APPLICATION NO.	FILING DATE	FIRST NAMED INVENTOR	ATTORNEY DOCKET NO.	CONFIRMATION NO	
09/827,141	04/06/2001	· Gang He	AP639US 5105		
7590 11/05/2003			EXAMINER		
Thomas Adams			TURNER, SAMUEL A		
Thomas Adams P.O. Box 11100			ART UNIT PAPER NUMBER		
Ottawa, ON K2H 7T8			2877		
CANADA			DATE MAILED: 11/05/2003

K					
	Applicatio	n No.	Applicant(s)						
•	09/827,14	l	HE ET AL.						
Office Action Summary	Examiner		Art Unit						
•	Samuel A.	Turner	2877						
The MAILING DATE of this communication appears on the cover sheet with the correspondence address Period for Reply									
A SHORTENED STATUTORY PERIOD FOR REPLY IS SET TO EXPIRE 3 MONTH(S) FROM THE MAILING DATE OF THIS COMMUNICATION. - Extensions of time may be available under the provisions of 37 CFR 1.136(a). In no event, however, may a reply be timely filed after SIX (6) MONTHS from the mailing date of this communication. - If the period for reply specified above is less than thirty (30) days, a reply within the statutory minimum of thirty (30) days will be considered timely. - If NO period for reply is specified above, the maximum statutory period will apply and will expire SIX (6) MONTHS from the mailing date of this com

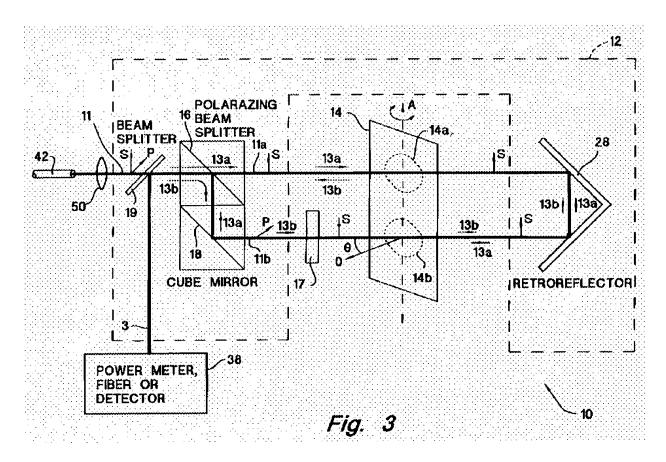
In claims 25 and 26 there is no antecedent basis for "the pair of reflectors".

Antecedent basis for "the pair of reflectors" can be found in claim 24.
